AGENDA ITEM #: 22

FILE #: 7-SB-24-C

SUBDIVISION REPORT -CONCEPT/DEVELOPMENT PLAN

► FILE #: 7-SB-24-C	AGENDA ITEM #: 22
7-D-24-DP	AGENDA DATE: 7/11/2024
SUBDIVISION:	MAYNARDVILLE PIKE SUBDIVISION
APPLICANT/DEVELOPER:	CONNOR P. KELLY
OWNER(S):	Connor P. Kelly Heritage Land Development Partners
TAX IDENTIFICATION:	29 001 View map on KGIS
JURISDICTION:	County Commission District 7
STREET ADDRESS:	7933 MAYNARDVILLE PIKE
► LOCATION:	West side of Maynardville Pike, southeast of Gray Road
GROWTH POLICY PLAN:	Planned Growth Area
WATERSHED:	Beaver Creek
APPROXIMATE ACREAGE:	58.47 acres
ZONING:	PR (Planned Residential) < 2.6 du/ac, F (Floodway)
EXISTING LAND USE:	Agriculture/Forestry/Vacant Land
PROPOSED USE:	Detached residential subdivision
SURROUNDING LAND USE AND ZONING:	North: Agriculture/forestry/vacant land, single family residential - A (Agricultural) South: Agriculture/forestry/vacant land - A (Agricultural) East: Rural residential, agriculture/forestry/vacant land - A (Agricultural), F (Floodway) West: Single family residential, agriculture/forestry/vacant land - A (Agricultural), RA (Low Density Residential)

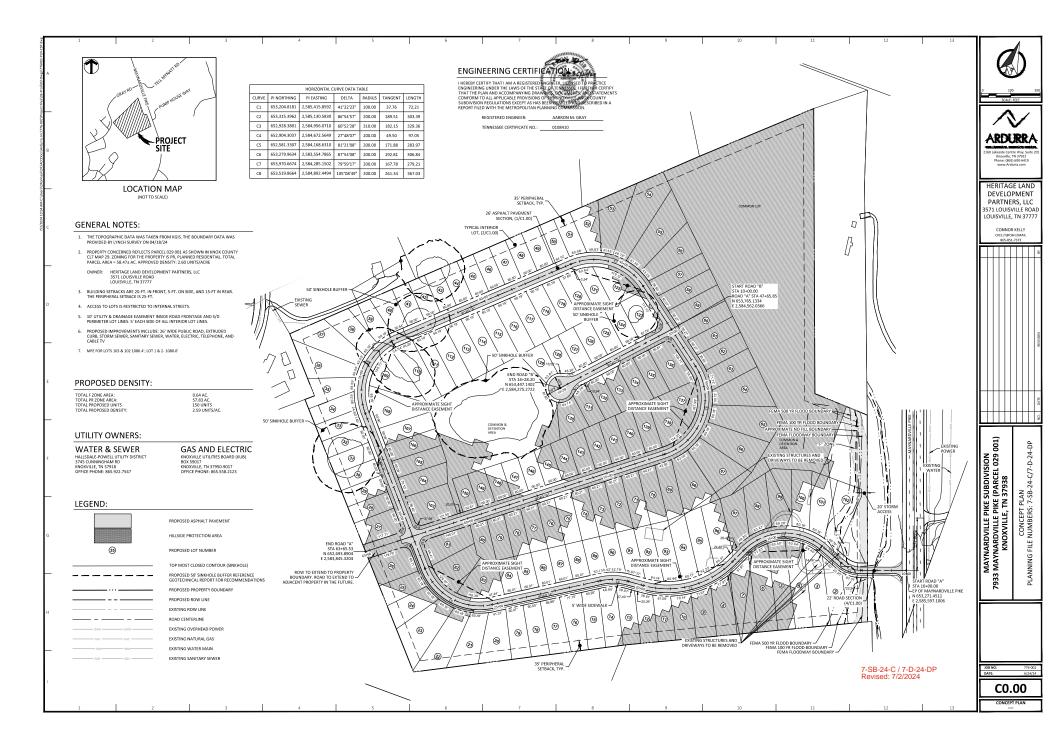
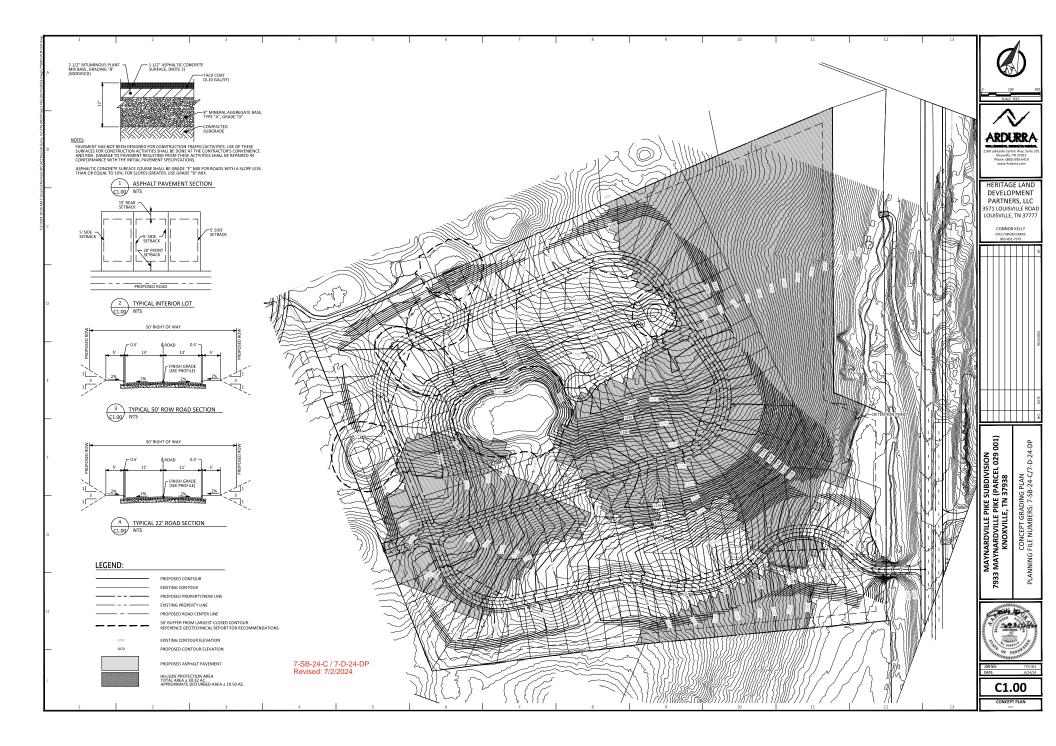
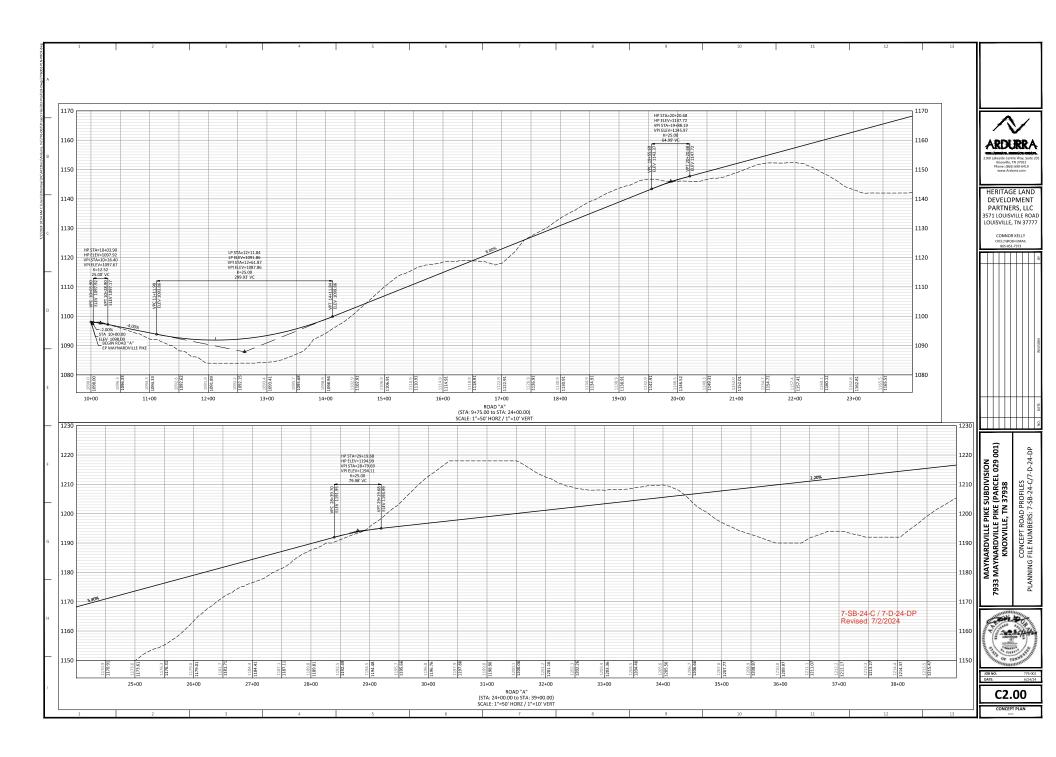
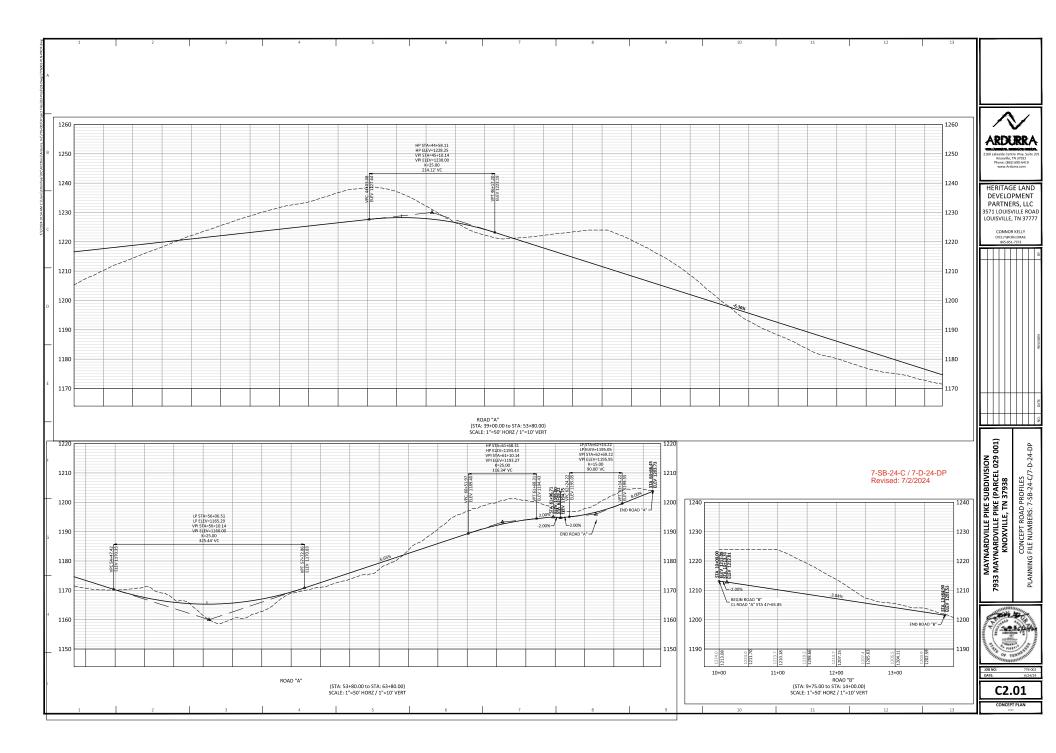
NUMBER OF LOTS:	150
SURVEYOR/ENGINEER:	
ACCESSIBILITY:	Access is via Maynardville Pike, a four-lane major arterial and center turn lane with 58 ft of pavement width within a right-of-right that varies in width from 340-545 ft.
SUBDIVISION VARIANCES REQUIRED:	VARIANCES 1) Reduce the minimum intersection separation along Maynardville Pike, between the centerlines of Road 'A' and Tell Mynatt Road, from 400 ft to 175 ft. 2) Reduce the minimum vertical curve K value on Road 'A' at STA 62+69.22 from 25 to 15.
	ALTERNATIVE DESIGN STANDARDS REQUIRING KNOXVILLE-KNOX COUNTY PLANNING COMMISSION APPROVAL 1) Reduce the minimum horizontal curve radius on Road 'A' from 250 ft to 100 ft at curve C1.

2) Reduce the minimum horizontal curve radius on Road 'A' from 250 ft to 200 ft at curve C2.

3) Reduce the minimum horizontal curve radius on Road 'A' from 250 ft to 200 ft at curve C4.

4) Reduce the minimum horizontal curve radius on Road 'A' from 250 ft to 200 ft at curve C5.

5) Reduce the minimum horizontal curve radius on Road 'A' from 250 ft to 200 ft at curve C6.

6) Reduce the minimum horizontal curve radius on Road 'A' from 250 ft to 200 ft at curve C7.

7) Reduce the minimum horizontal curve radius on Road 'A' from 250 ft to 200 ft at curve C8.

1. Reduce the minimum pavement width for a public road from 26 ft to 22 ft on Road 'A' from STA 0+00 to 7+00.

2. Increase the maximum intersection grade from 1 percent to 3 percent on Road 'A' at Maynardville Pike.

3. Increase the maximum intersection grade from 1 percent to 3 percent on Road 'B' at Road 'A'

Approve the requested variance to reduce the minimum intersection spacing along Maynardville Pike, between the centerlines of Road 'A' and Tell Mynatt Road, from 400 ft to 175 ft.

Approve the requested variance to reduce the minimum vertical curve K value on Road 'A' at STA 62+69.22 from 25 to 15.

Approve the alternative design standards based on the justification provided by the applicant and recommendations of the Knox County Department of Engineering and Public Works.

Approve the Concept Plan subject to 12 conditions.

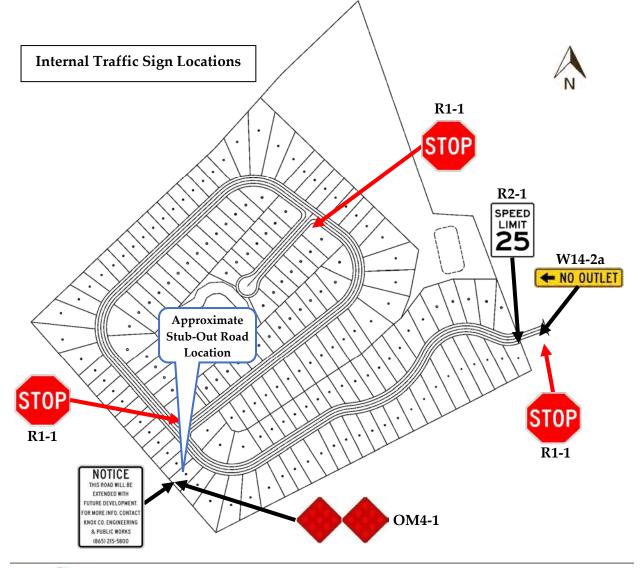
- 1e) Even though a southbound right-turn lane on Maynardville Pike is not warranted in the projected conditions, the developer is encouraged to begin coordination with TDOT early in the permitting process. Other modifications may be necessary at TDOT's discretion, including an increased radius for southbound right turns and potentially strengthening the asphalt pavement on the shoulder to facilitate vehicles turning off the higher-speed highway.
- 1f) Knox County requires a 400foot minimum intersection spacing distance on Arterial roads. The intersection of Maynardville Pike, an arterial road, at the Proposed Entrance will be 185 feet away to the southeast from Tell Mynatt Road/Pump House Way (centerline to centerline).

The site designer must request a variance to allow

the proposed intersection spacing to be less than the minimum required. This variance should be requested since the development property has limited access opportunities on Maynardville Pike due to the topography and the adjacent creek on the highway's west side.

Since it is a free-flow movement, southbound right-turn movements from Maynardville Pike into the proposed subdivision will not create vehicle queues on Maynardville Pike. Thus, these movements will not interfere with turning movements on Maynardville Pike at Tell Mynatt Road/Pump House Way. These offset intersections will not have any conflicting movements, will have low turning movements from each, and vehicle queues are not expected to impact operations at either intersection.
